1435 - P045a

Entrance Hall//Existing//Plan_1:20

1435 - P062

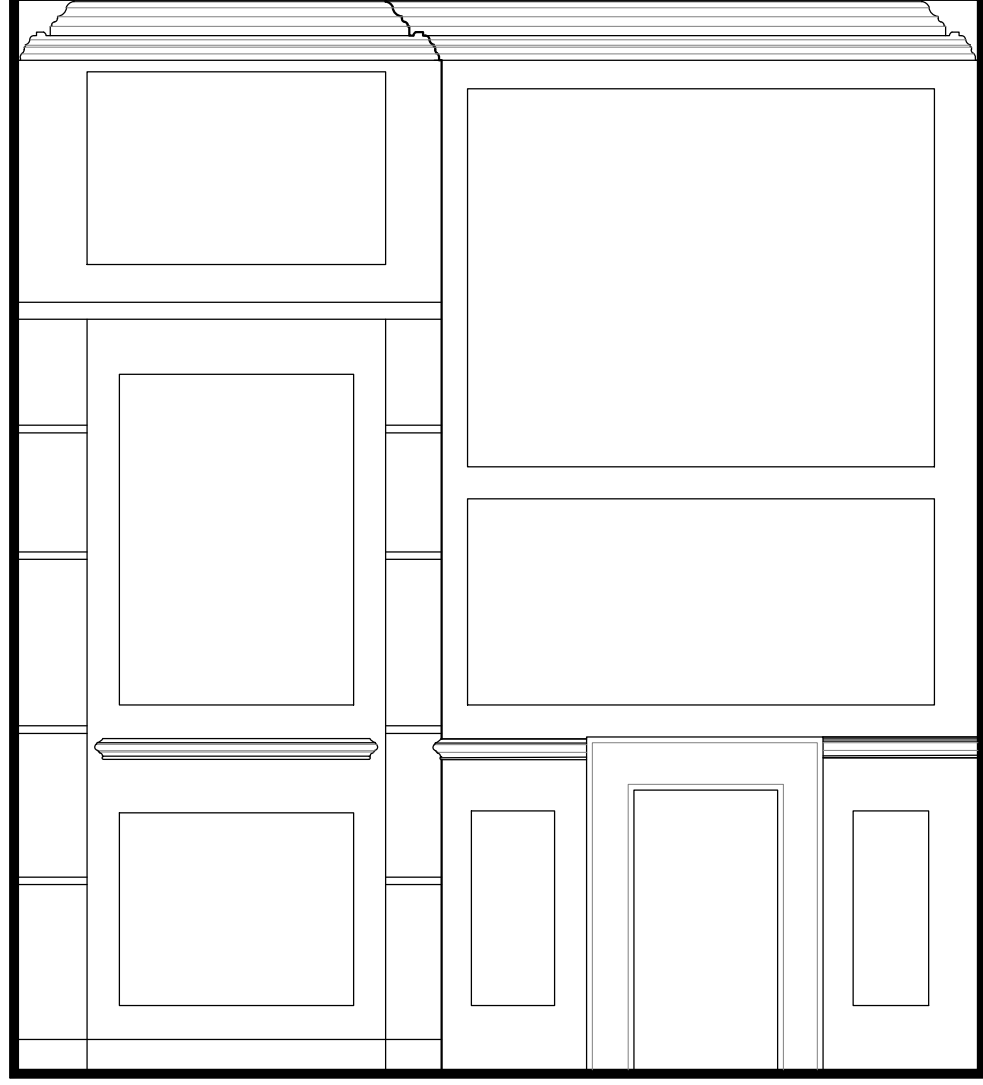
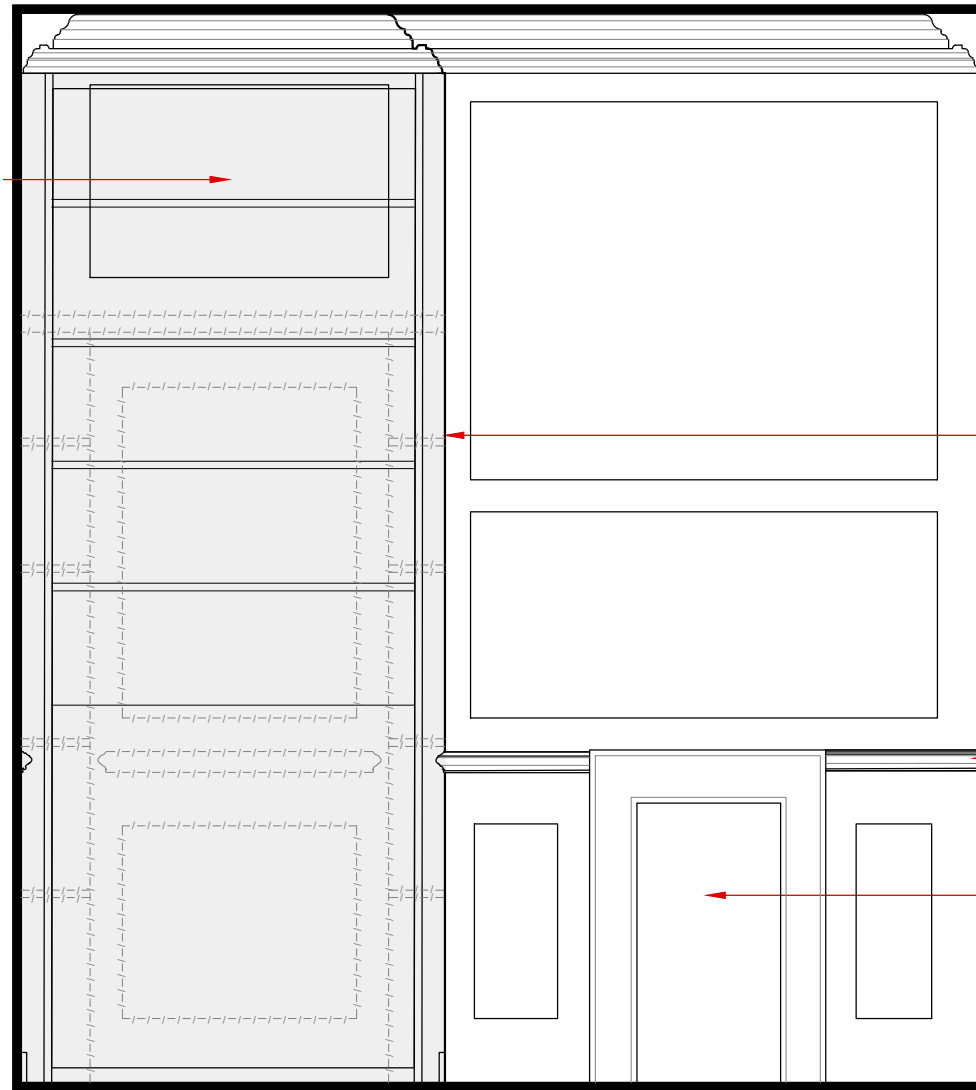
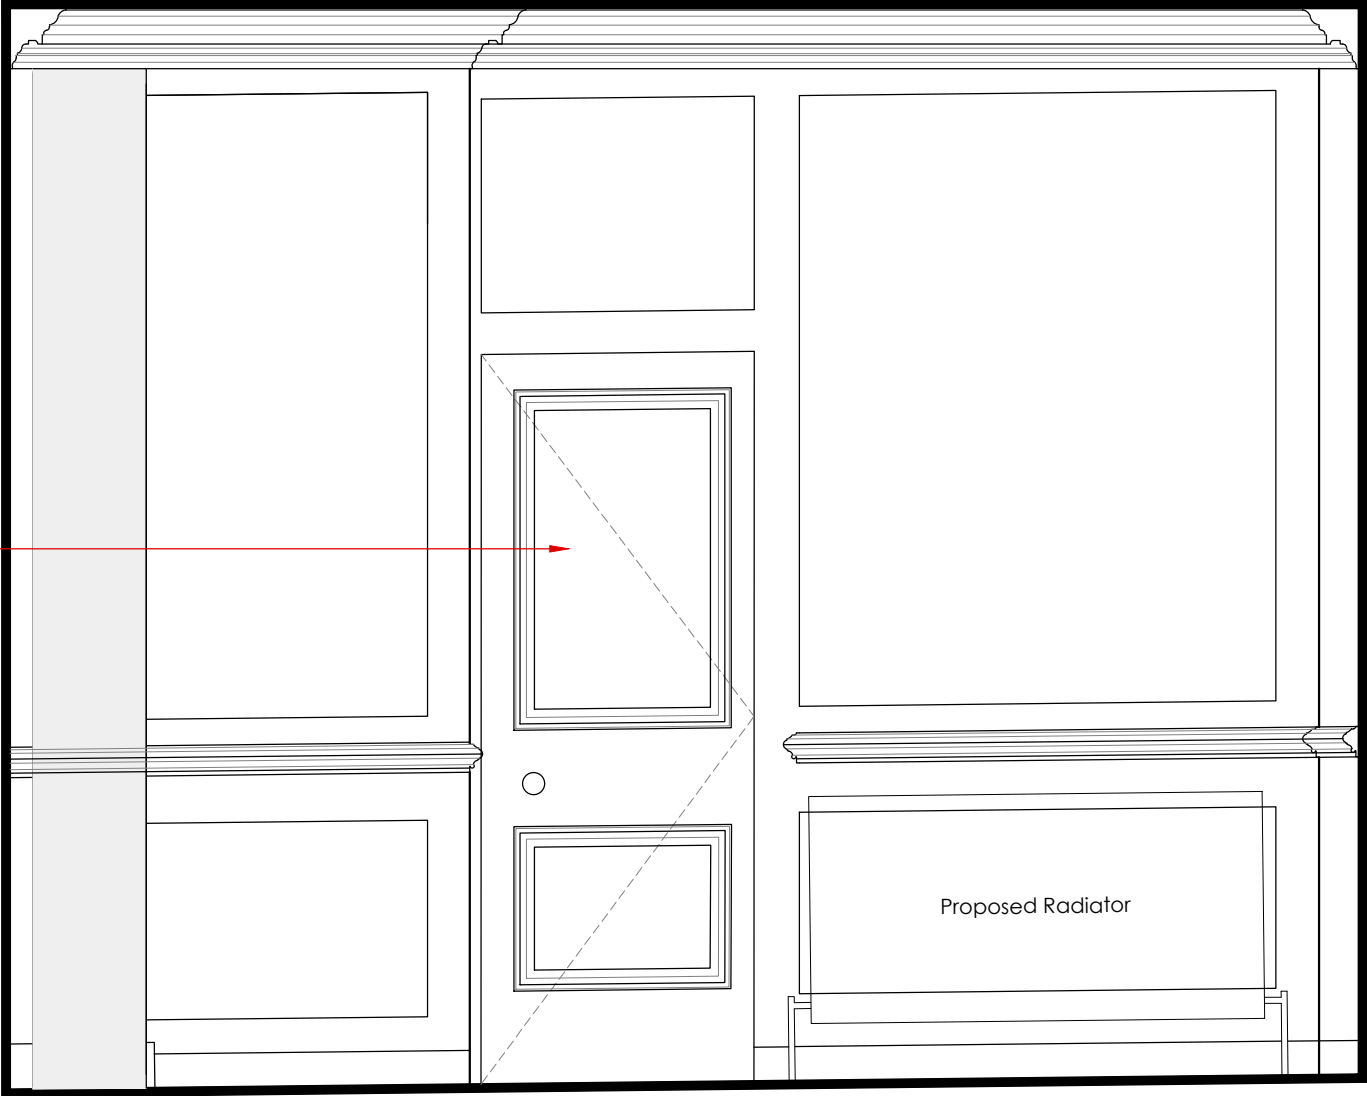
Remove boxing back to wall and remove all existing pipework.

Existing cornice and panelling to retain.

Proposed joinery to be scribed into the walls.

Proposed bookcase with
panelling behind
retained.

Top and side scribed
timber to fill gap
between proposed
bookshelf. Panelling to
remain as existing

Existing miss matched
dado railing to be
justified to single style.

Existing marble surround
retained. Remove timber
shelves and reline
existing fireplace.

Proposed 2 panel door
to match D.G.06.

Rev	Date	Notes
A	23.06.15	Radiator added.

1435 - P065

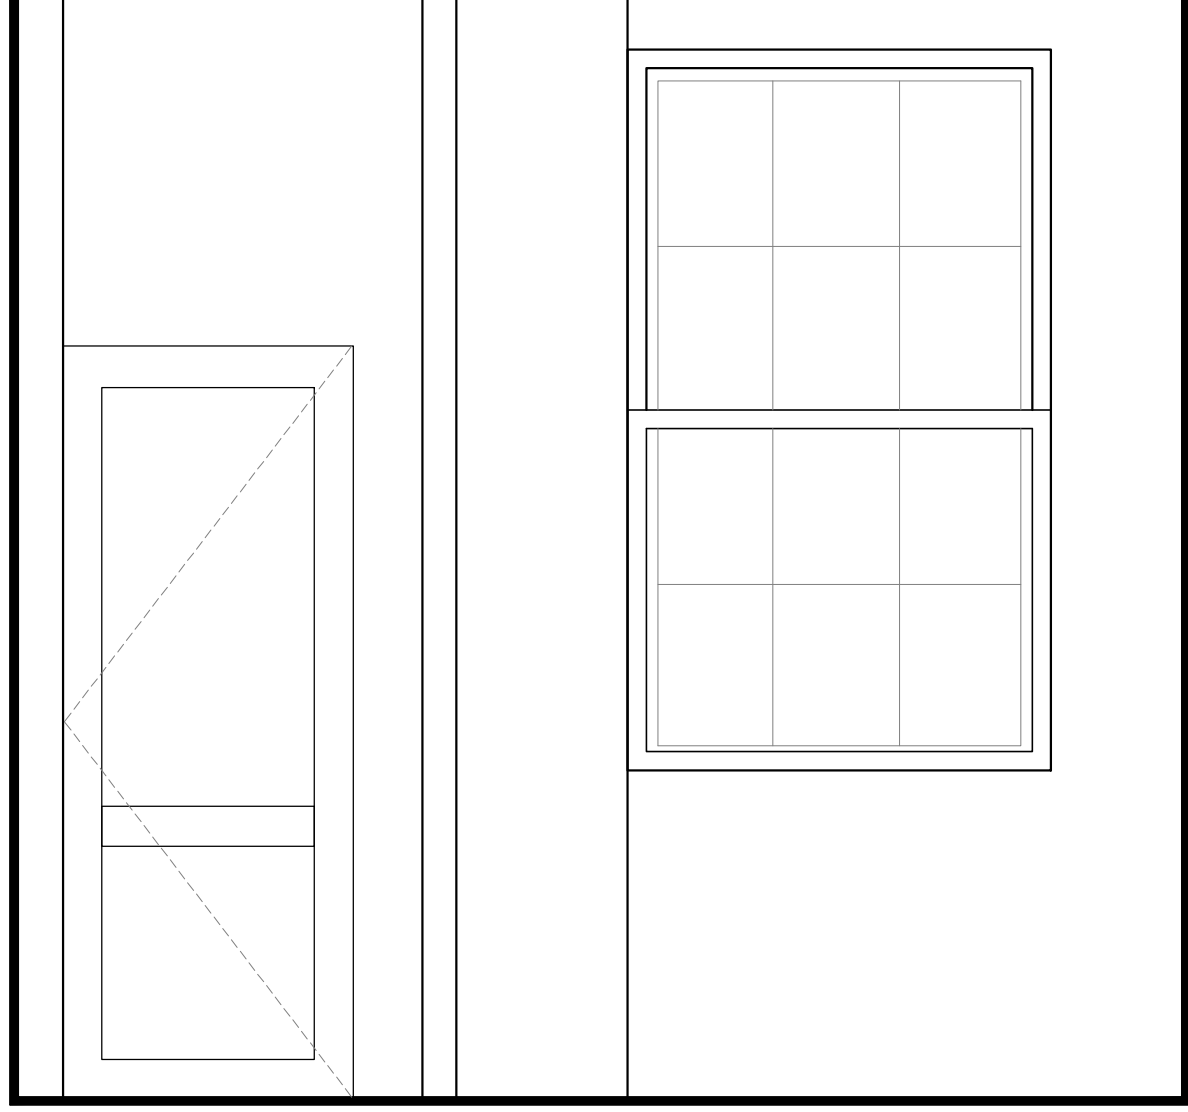
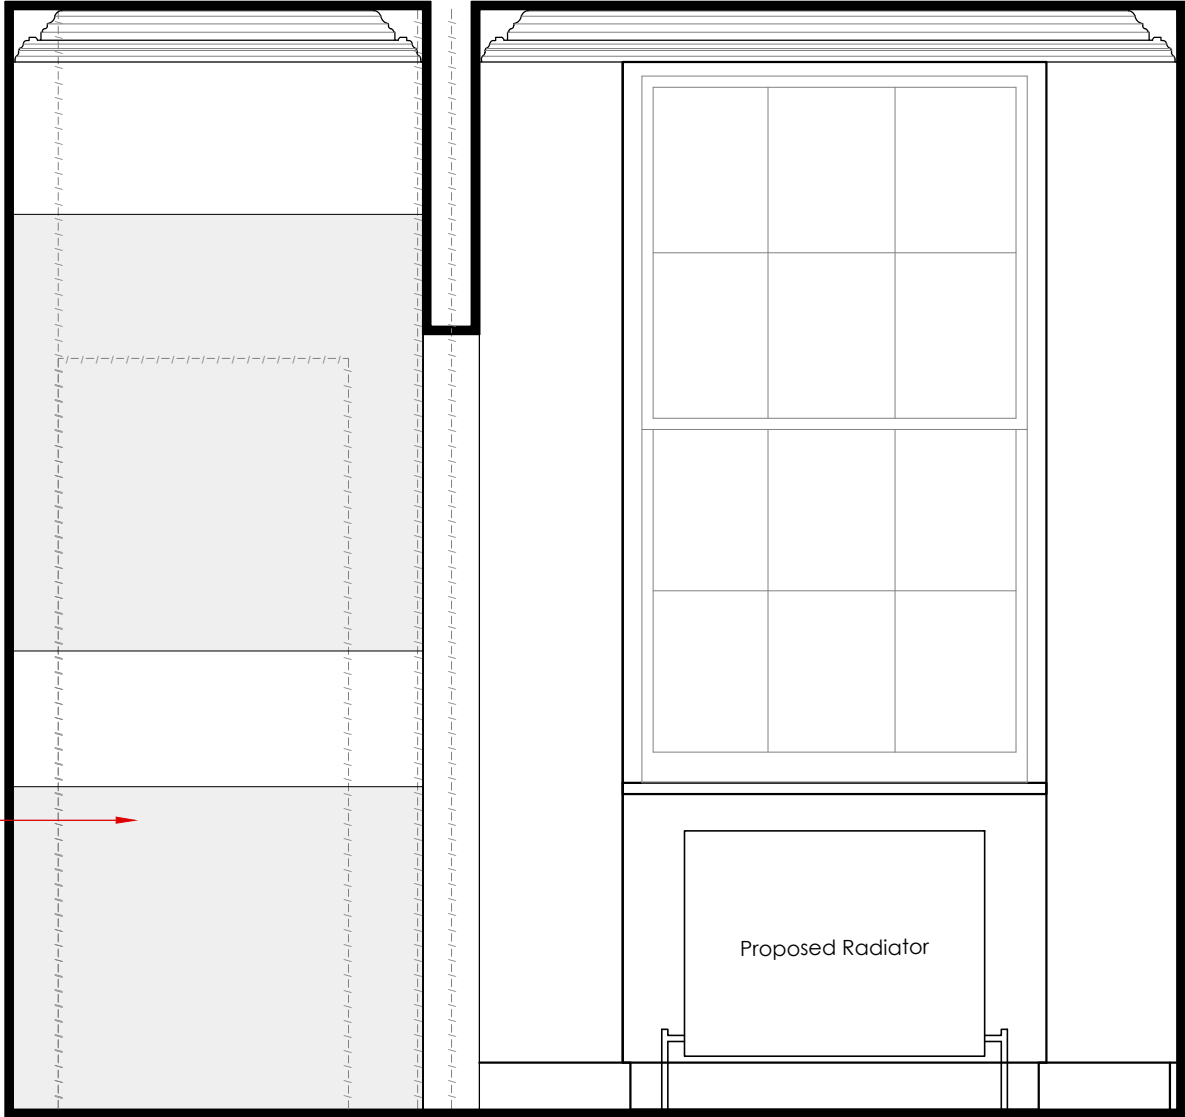
Proposed fixed joinery
to be within new
alcove.

Rev	Date	Notes
A	23.06.15	Joinery location revised and radiator added.

1435 - P268a

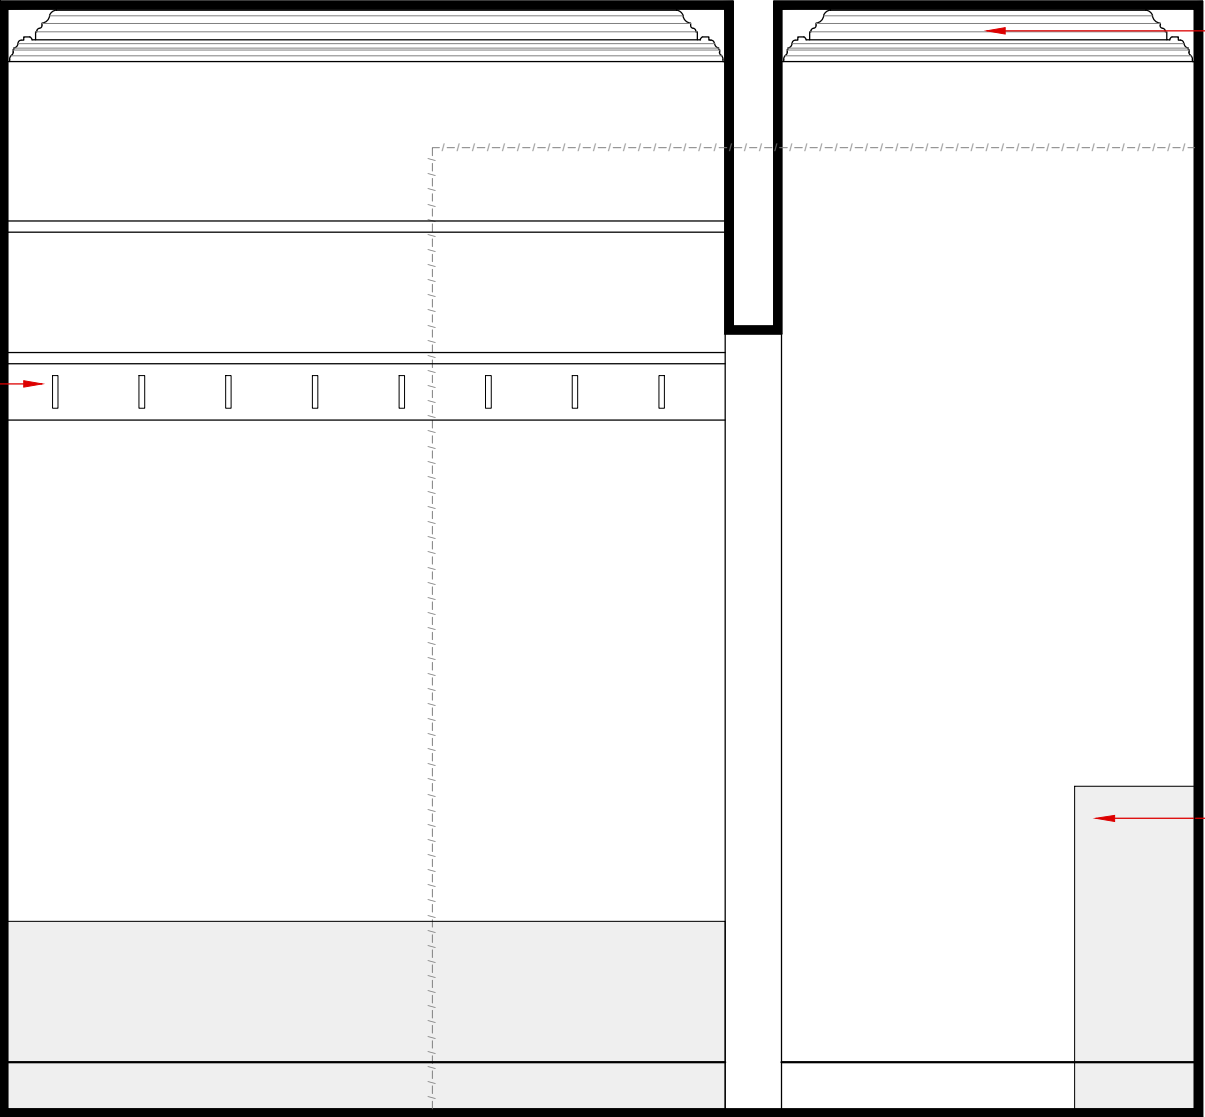
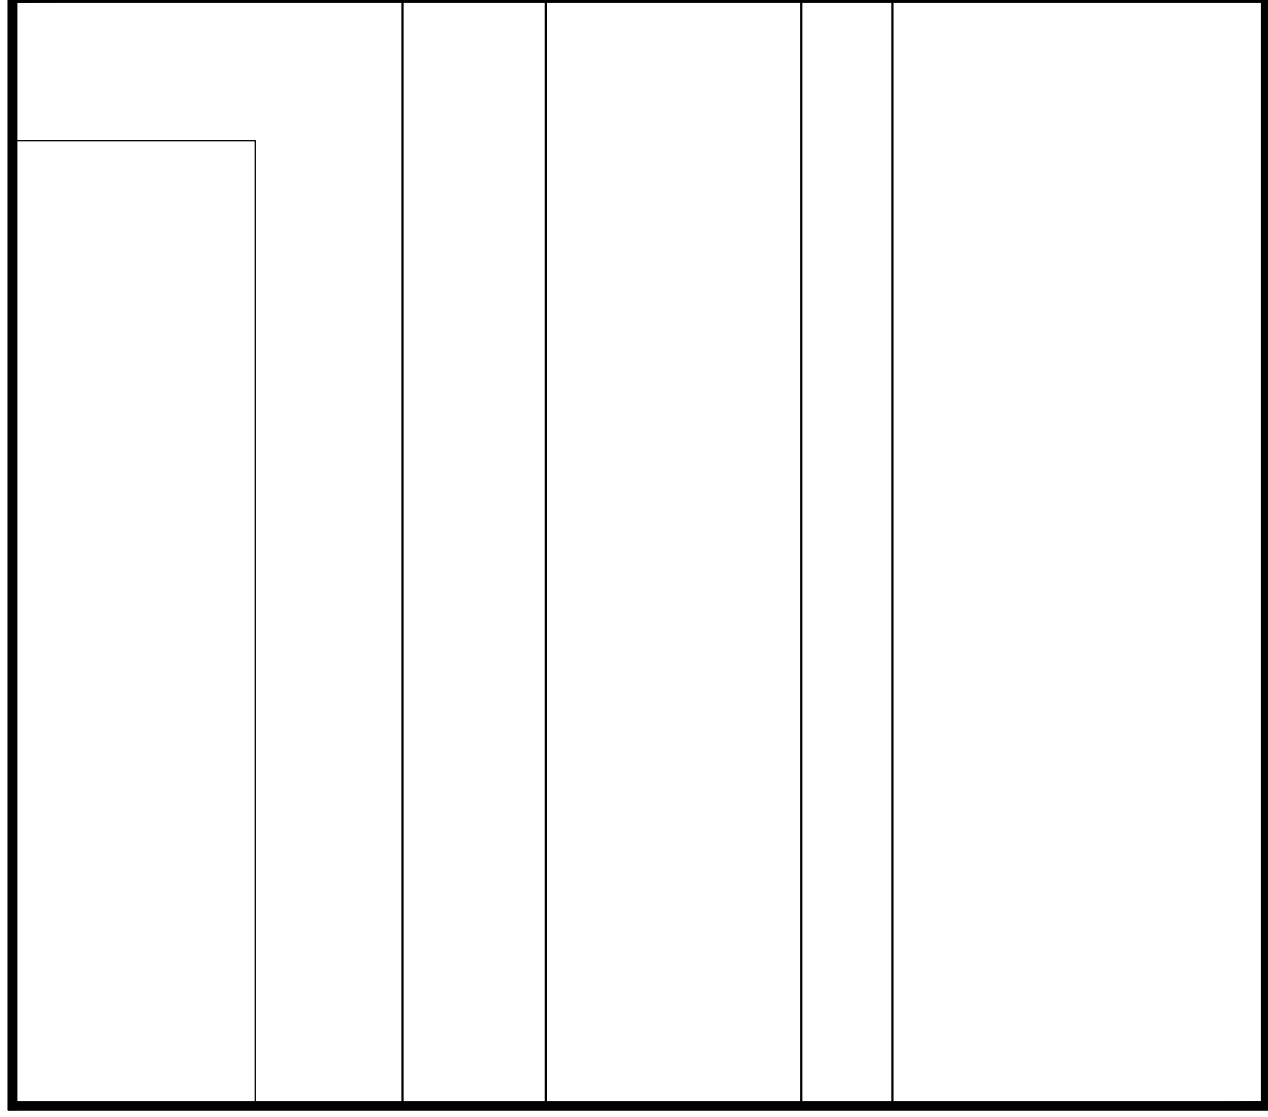
Proposed coat hooks
fixed to timber plate.

Proposed cornice to run
in front of joinery.
Cornice to match
existing with Drawing
Room.

Proposed fixed joinery
to be within new
alcove.

Rev	Date	Notes
A	23.06.15	Joinery revised.

1435 - P069

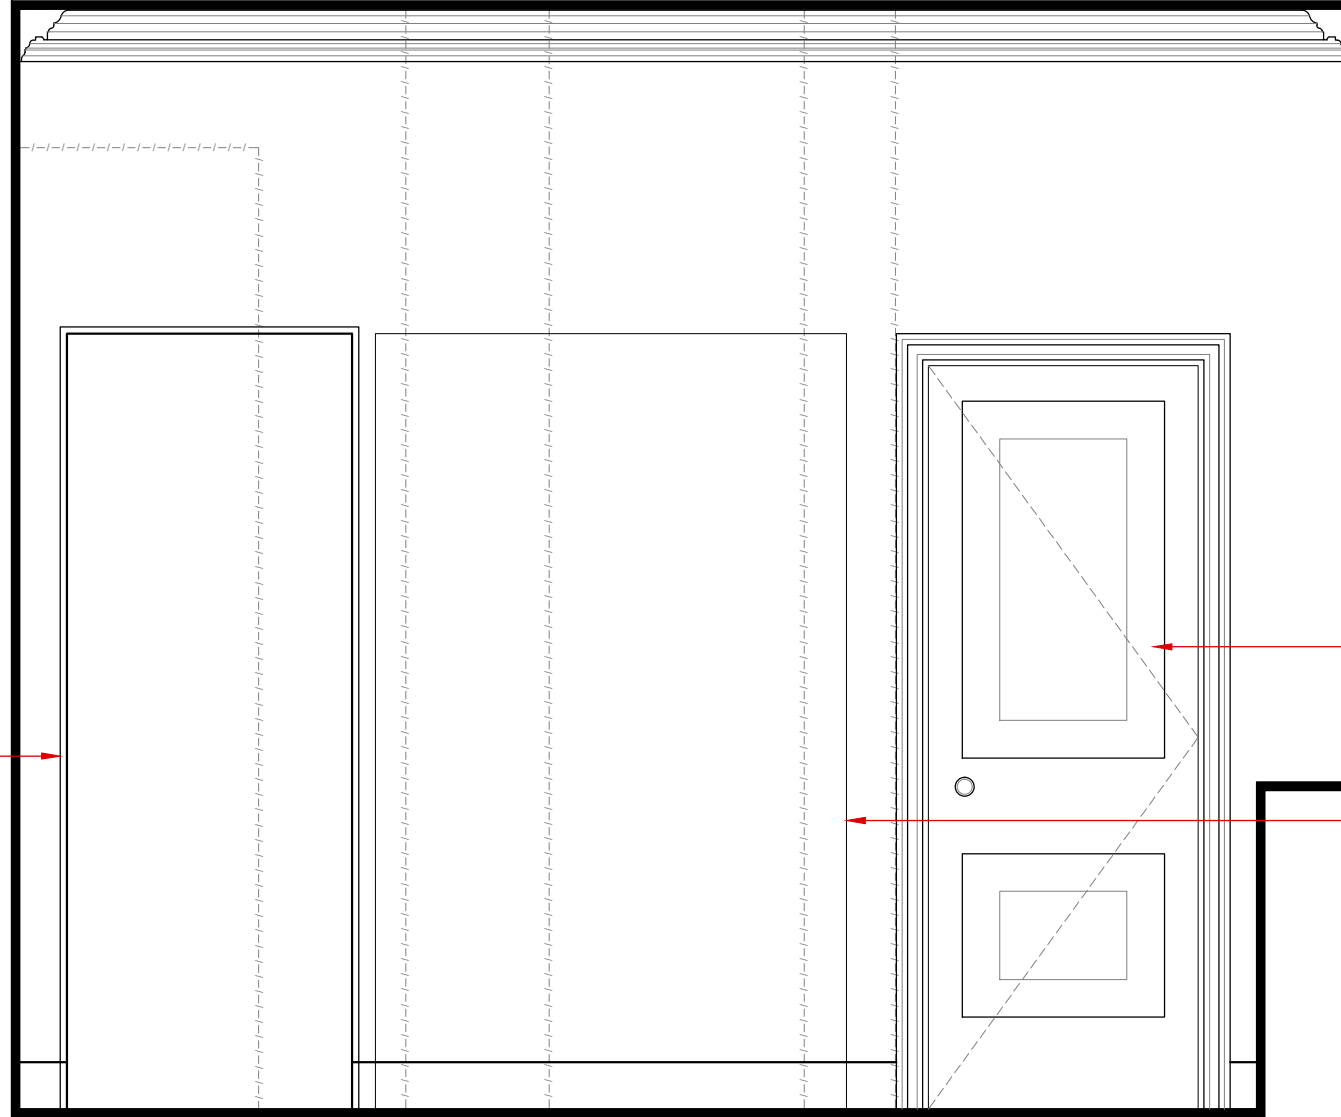
Proposed 18mm dowel
trim to edge.

Proposed 2 panel door
to match D.G.06.

Proposed freestanding
furniture.
